# Apex Yarn Dyeing Ltd.

18th October & 1st November 2021

# Observations

Winding portion

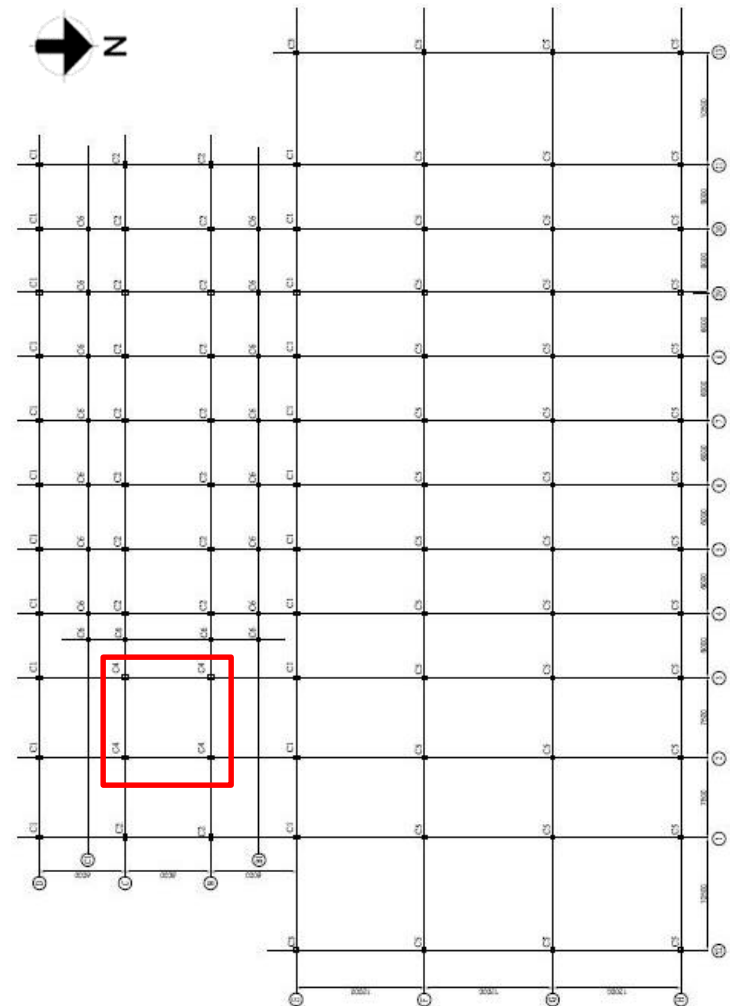
Roof bracing is not provided

Tie beam is provided along the long direction (periphery only). Some horizontal bracing are provided from truss to truss but roof bracing is not provided. Factory engineer is required to check the lateral stability system of the structure and review the design accordingly.

Column schedule

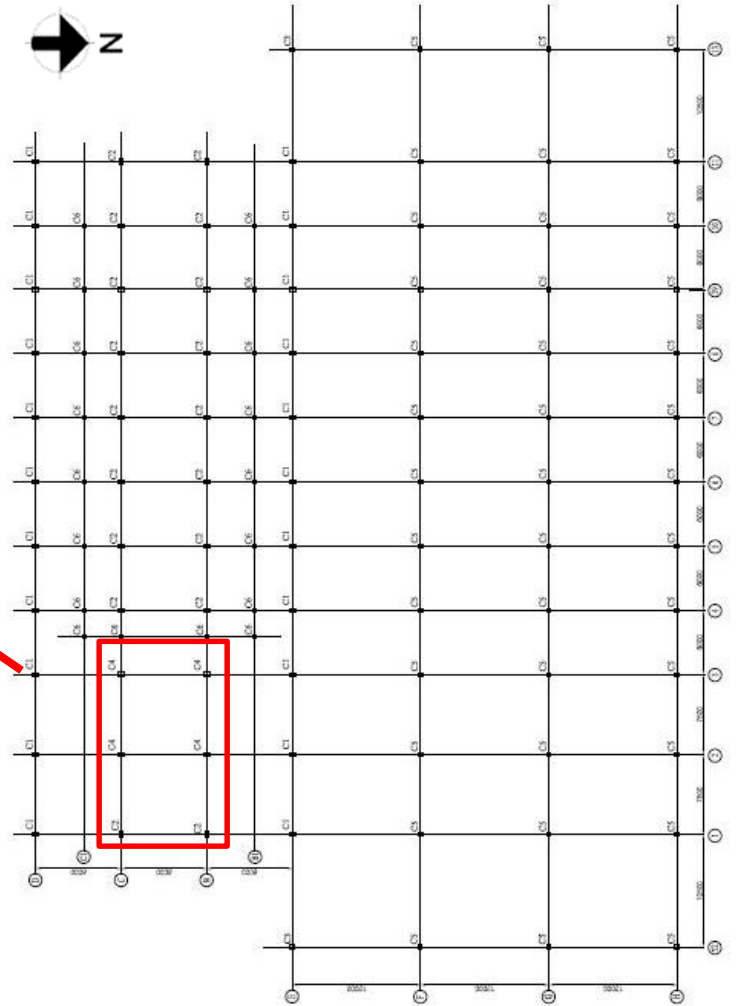
Ferro-scan shows 2-rebar along short face instead of 3-rebar (C-5)

Number of rebar of column C-5 found 6 instead of 8. Factory engineer is required to survey the structure, update the structural drawing and check the column capacity accordingly.

Steel stair at east side

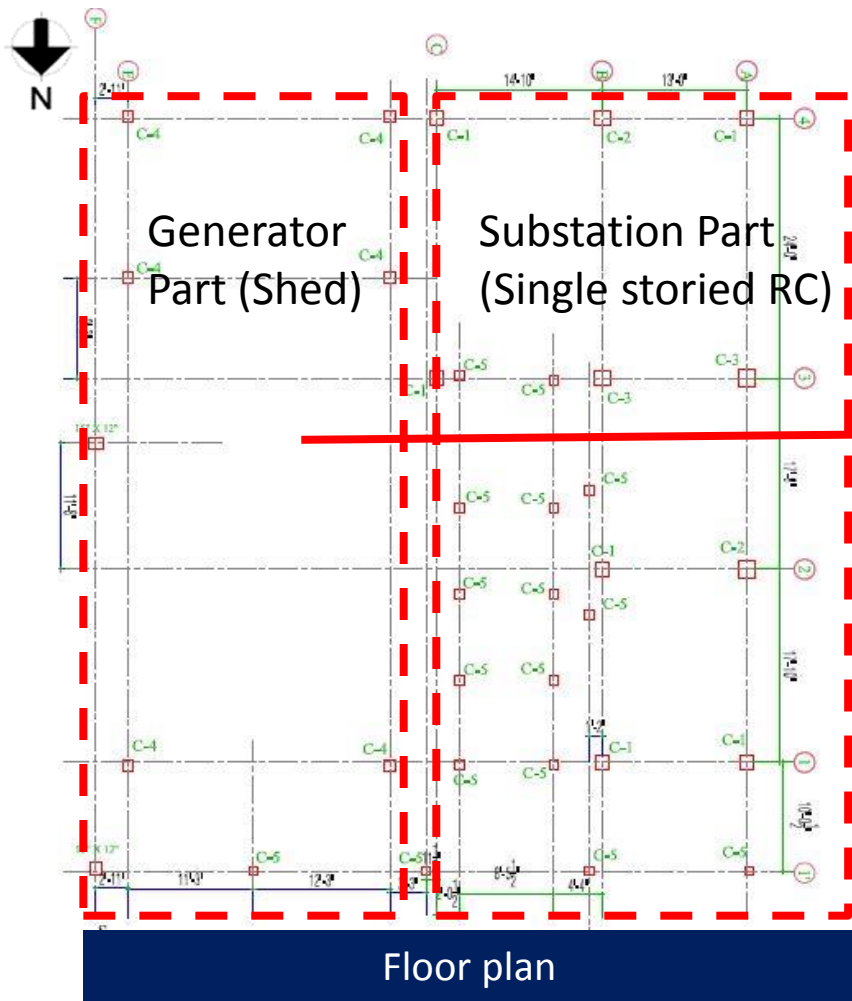
No bracing system is provided

Steel stair found at either side (East & West) of Dyeing & Winding Shed. No bracing system is provided to withstand the lateral load therefore there is no obvious stability system in those steel stairs. Factory engineer is required to check the lateral stability for both steel stair.

Truss found as out of plumb (Steel part)

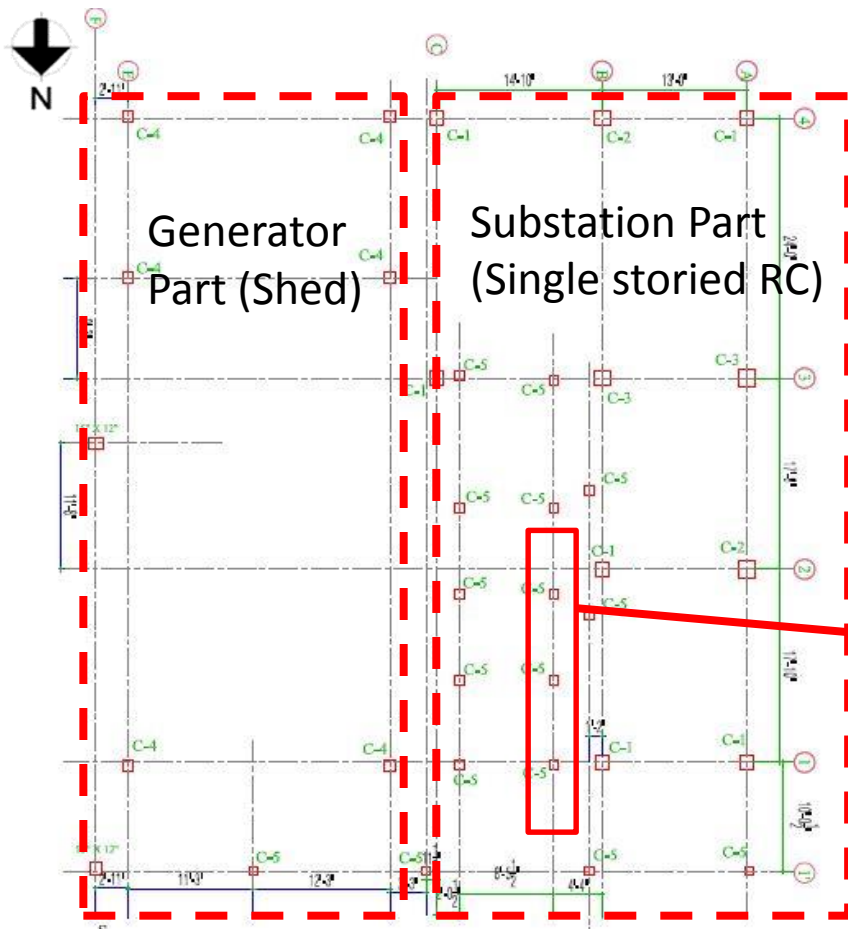
Poor connection between truss and RC column (Steel part)

Truss was found out of plumb, and a poor connection was found between truss and RC column at Steel part. Factory is required to check the truss alignment, support condition and suggest proper remedial actions accordingly.
